### **STAFF FINDINGS:**

I move that the Commission issue a certificate of appropriateness for the application at 407 West Mosley Street, a contributing property in the Old West Side Historic District, to construct a 618 square foot addition on the rear elevation of the house, and an 8’ x 24’ deck behind the addition, with the following condition: that the clad windows and patio doors have no grilles between the glass, and that either muntins in the patterns shown are applied on the interior and exterior with spacers or that no muntins be used at all. As conditioned, the work is compatible in exterior design, arrangement, texture, material and relationship to the rest of the building and the surrounding area and meets *The Secretary of the Interior’s Standards for Rehabilitation* and *Guidelines for Rehabilitating Historic Buildings*, in particular standards 2, 5, 9, and 10 and the guidelines for building site, additions and roofs, as well as the *Ann Arbor Historic District Design Guidelines* for all additions, residential additions, and roofs.

SUI MADDEN RESIDENCE  
- ADDITION  
407 W MOSLEY ST  
ANN ARBOR, MI 48103

**A1.0**

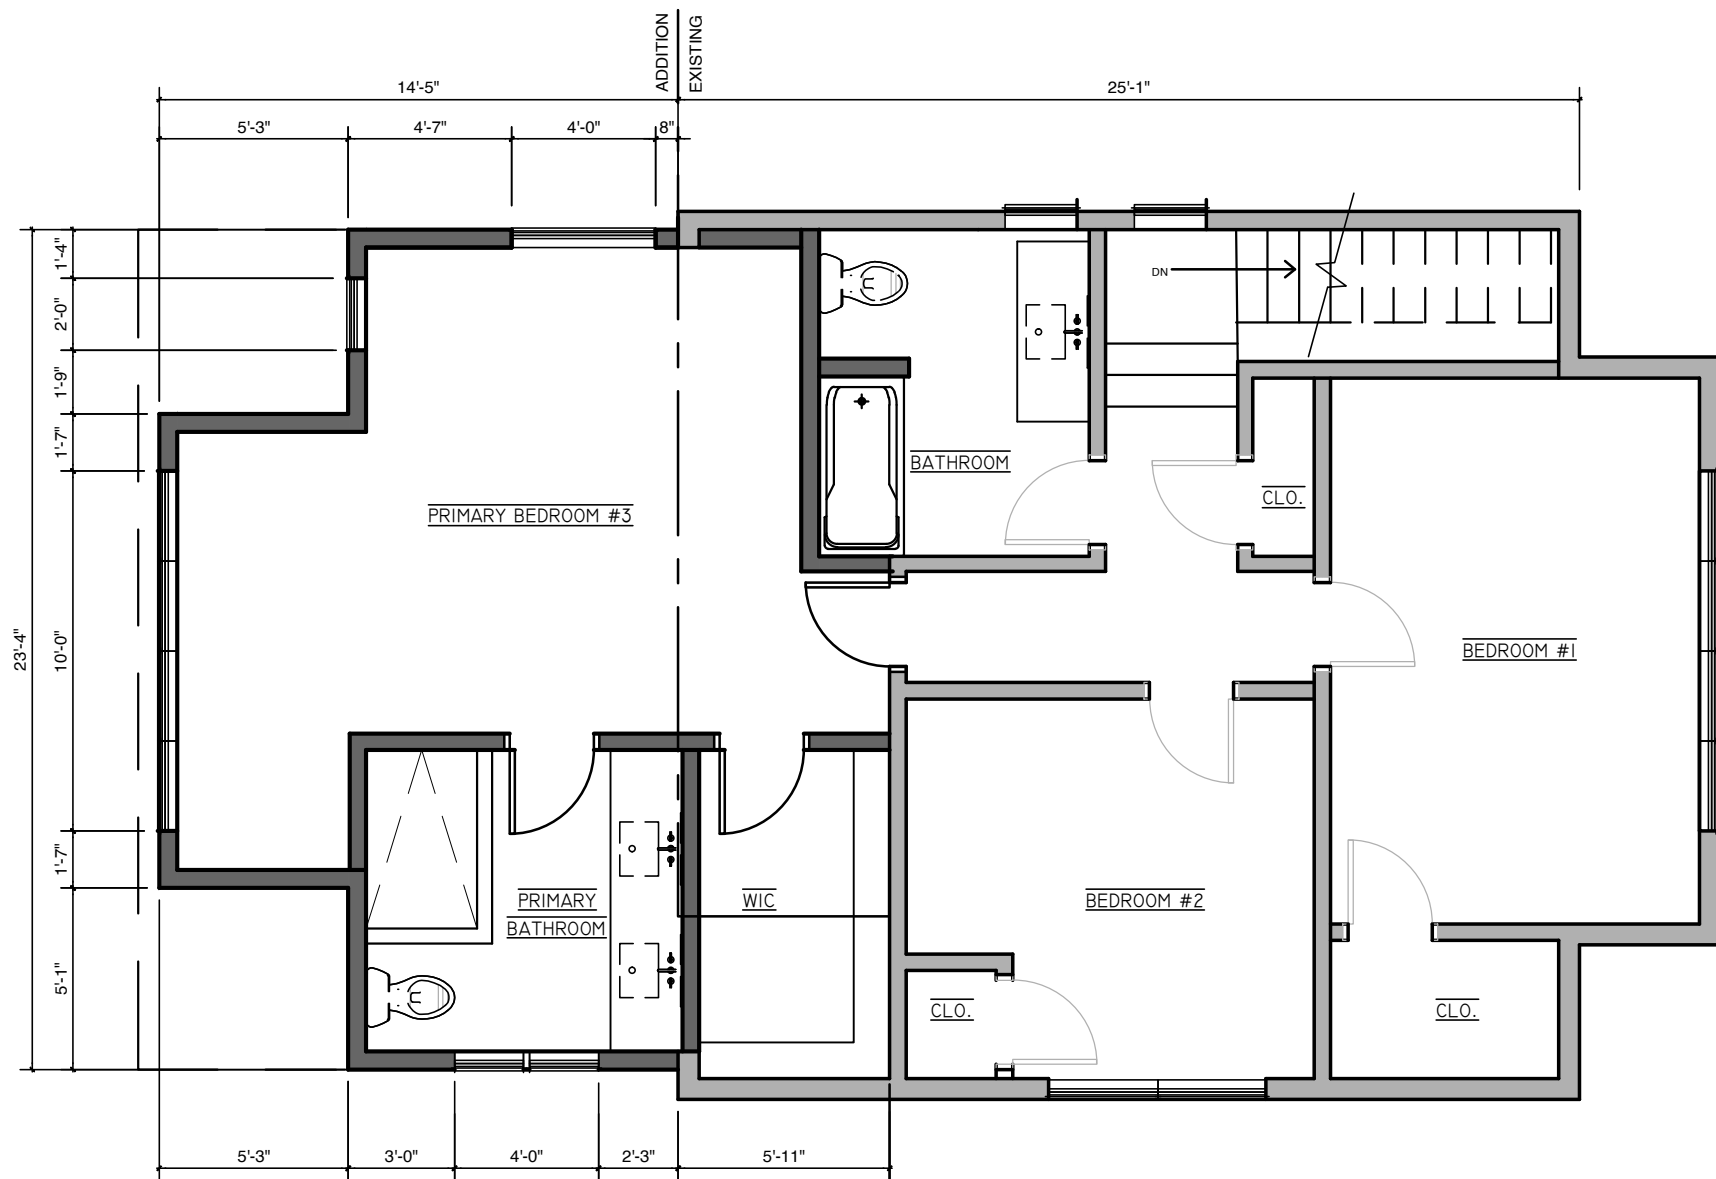
3. Four original windows and a door opening will be lost to the addition. Except for the east wall of the shed dormer, the side and front elevations will not be altered. The proposed deck has one step shown and is low enough that a guardrail is not required. Staff could not find decking materials, but either wood or imitation wood decking (like Trex) are appropriate.

4. The house's pre-1945 footprint was 724 square feet. The proposed addition adds 362 square feet, or 50%. The pre-1945 floor area was 1,336 square feet, and the two-story addition is 663 square feet, for an increase of 50%. This meets the design guideline that

**A2.1**

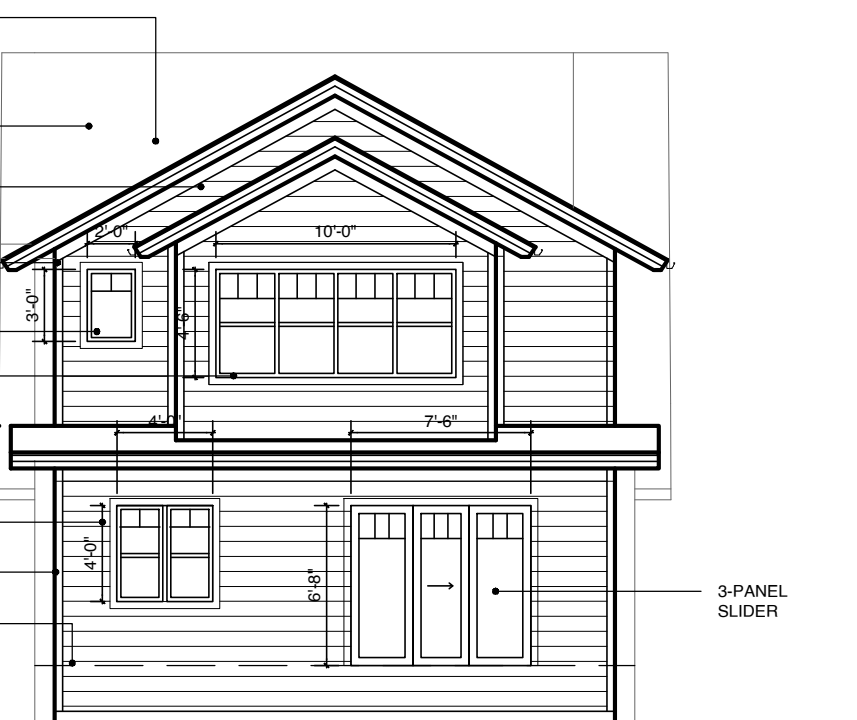
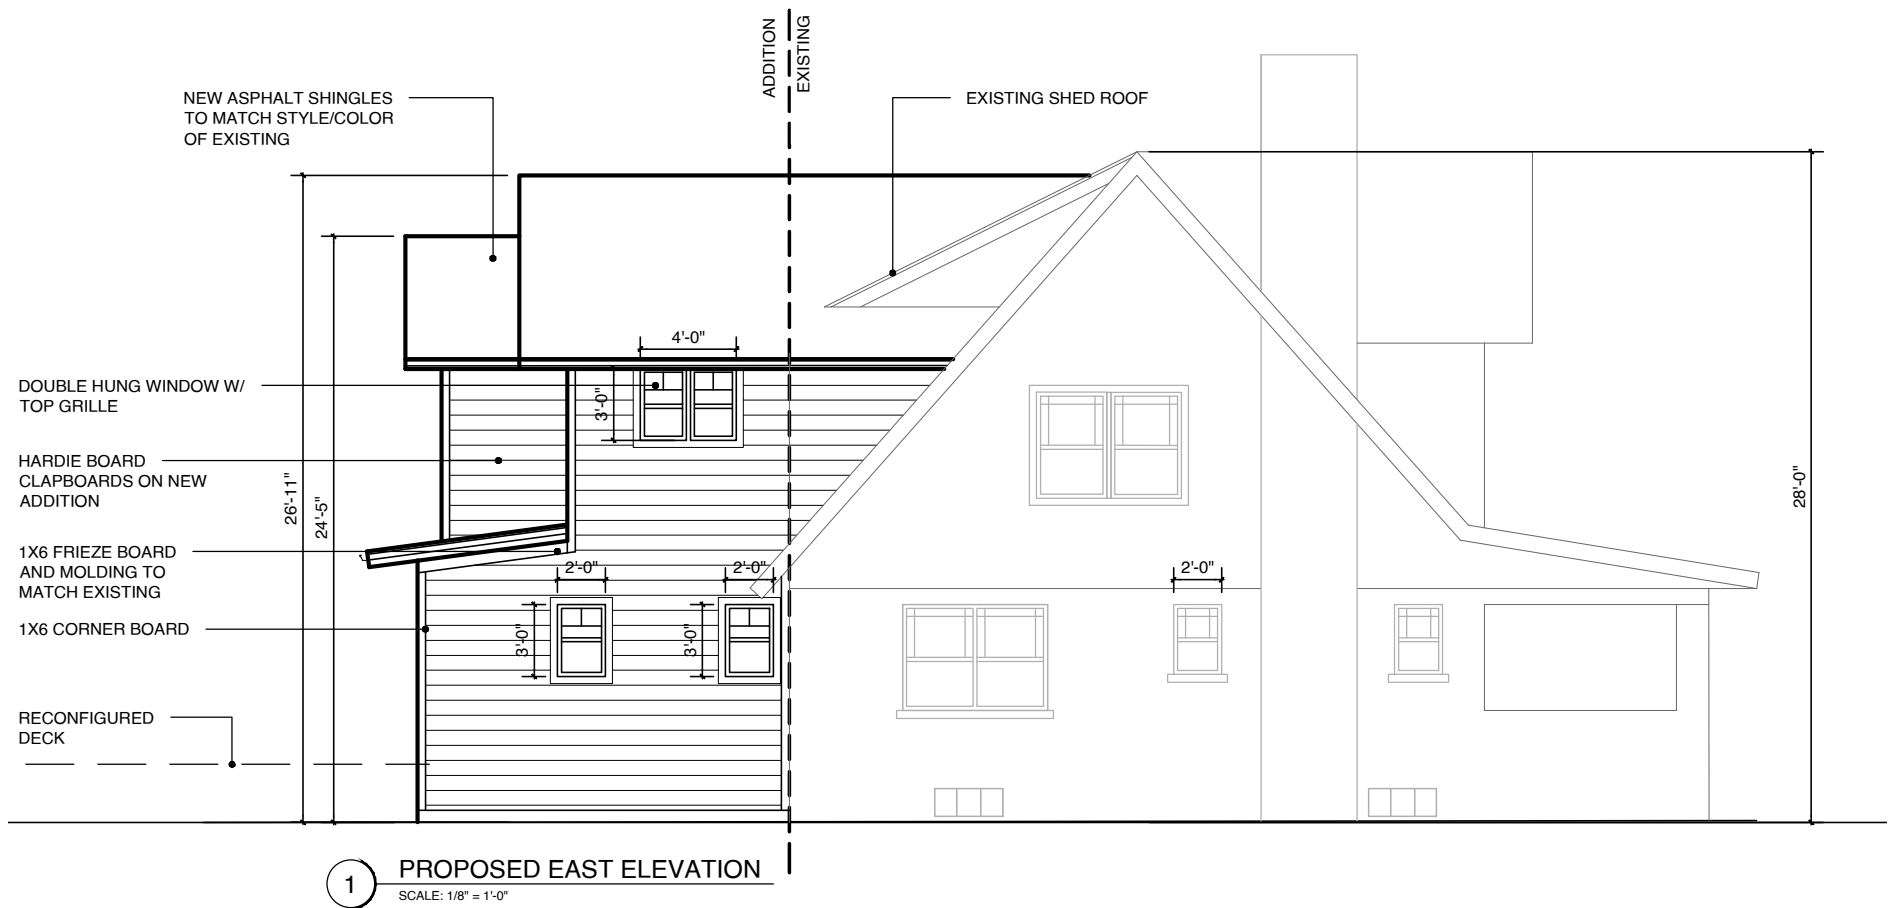
On the second-floor rear, the addition has a second gable roof over a narrower section that sits atop a first floor shed roof. This design feature benefits the addition by breaking up its second-floor massing and references the gable dormer on the front of the house.

2. The addition is clad in smooth Hardie Board plank siding with an 8" exposure. Windows on the addition are casement or double-hung, with each single or top-sash having a three-over-one design. These windows and a three-part patio door are aluminum clad with grilles between the glass. Since this design isn't appropriate, staff's suggested motion includes a condition that the windows and patio door have either no grilles or use muntins applied to the interior and exterior with spacers in the pattern shown. The pattern is modern looking but compatible with the historic sashes' muntins. The window shapes and sizes are varied from those on the historic house but still compatible.

**A2.2**

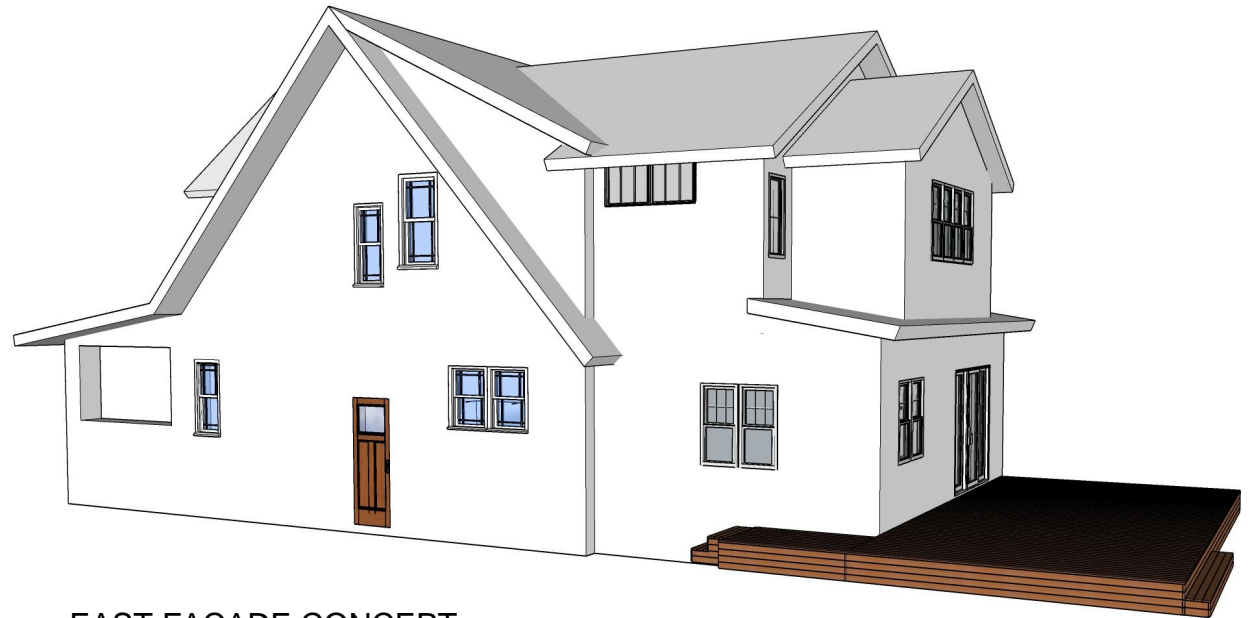
1. A two-story rear addition is proposed on the back of the house. A non-historic mudroom would be removed for the work. The new roof is set lower than the current ridge by about a foot. Staff finds this to be appropriate and has stressed to the design professionals the importance of keeping this new ridge lower than the existing one. The rear corners of the addition are inset by 10" on both sides. The addition has a gable roof that would be set in to the existing shed dormer. On the west side the shed dormer's eave is retained. The existing shed dormer doesn't span the width of the rear of the house, and the new addition would truncate its shed roof on the east elevation, leaving a triangular portion above the new roofline (see sheet A2.2).

5. The southwest corner of the addition will fall slightly behind the northeast corner of the garage/barn with about 6’ between the two. Staff believes the addition will not unduly impact the contributing garage/barn.
6. Staff’s concerns are mainly about the east side of the shed dormer. The HDC will need to determine whether this design adequately retains the shed dormer or if too much of it is lost; whether the work is inconspicuous; or whether the historic character is diminished by this design.
